SUTPHEN CORPORATION SALES TECHNICAL BULLETIN

ALUMINUM BODIES: NOTCH IN COMPARTMENTS L1/R1

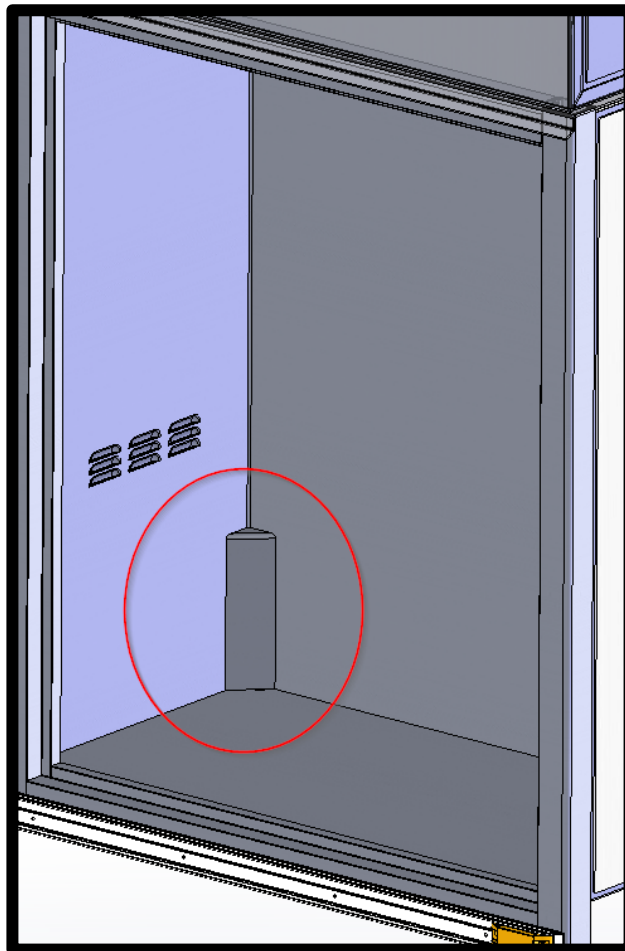
Effective immediately, all aluminum body pumpers built at the Dublin Facility will have a notch in the L1 & R1 compartment. This notch is to accommodate the optional air-ride suspension. By standardizing on this notch, it cleans up the parts database and reduces engineering body templates.
